**HOTEL ST. BERNARD**  
TAOS, NEW MEXICO

Re: Hotel St. Bernard – Village DRT Comment Responses

**TAOS SKI VALLEY, INC.'S OBJECTIONS AND RESPONSES  
TO VILLAGE OF TAOS SKI VALLEY'S "STAFF REPORT  
(REVISED AND UPDATED): CONDITIONAL USE PERMIT:  
HOTEL SAINT BERNARD, 112 SUTTON PLACE"  
(Filed January 30, 2023)**

CIVIL DRAINAGE PLAN

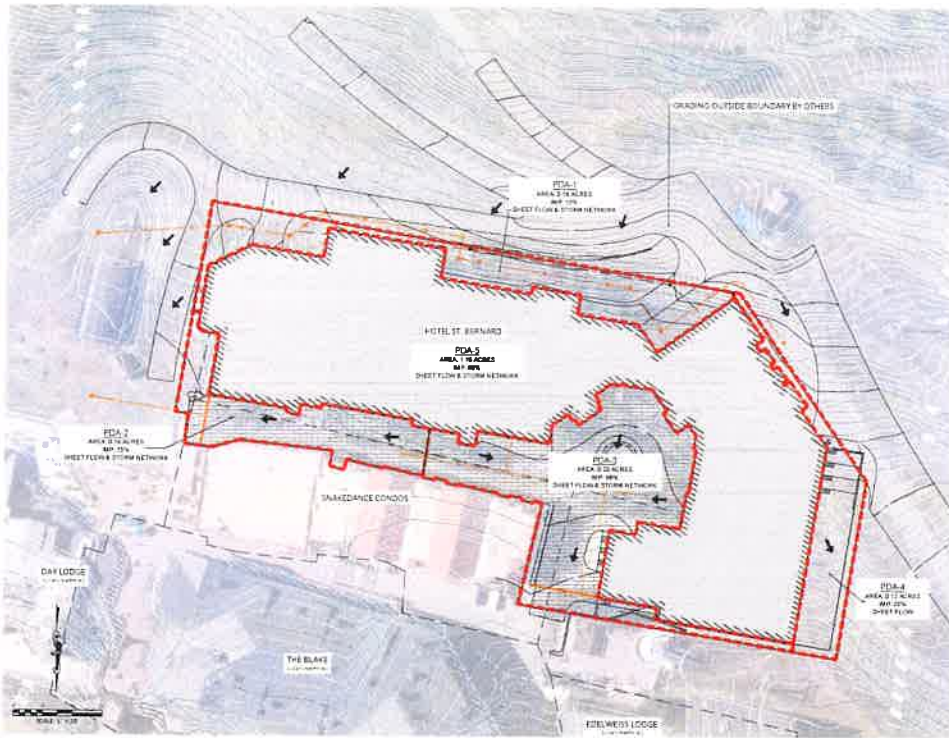
*The plan does not show the volume and structures that will be designed that will accommodate that volume. The discharge of the various systems is also not clear in the Civil Drainage Plan. How are the guttered drains connected to the stormwater systems, for example? A complete drainage plan is requested.*

**Vertex Response:**

**Method**

The overall watershed area will be evaluated to determine the drainage area contributing to the flows on the proposed site. Additionally, VERTEX will evaluate the existing storm infrastructure, along with the proposed improvements occurring prior to the construction of Hotel St. Bernard to determine the layout for the proposed storm infrastructure.

Existing and proposed drainage area maps including the area of each drainage basin, the impervious percentage associated with each area, the associated C-value and the flow generated by each basin will be provided with the COC submission.

The proposed drainage infrastructure will be designed to pick up the flow from the proposed development and the snow melt areas. A trench drain will be placed at the end of the drive from the main plaza area where the proposed snowmelt area meets the existing pavement. All landscape areas will be discharged into the creek and all hardscape areas routed to the regional water quality/detention pond. A plan with the proposed storm drainage system with the sizing, treatment and discharge locations will be provided with the COC submission.
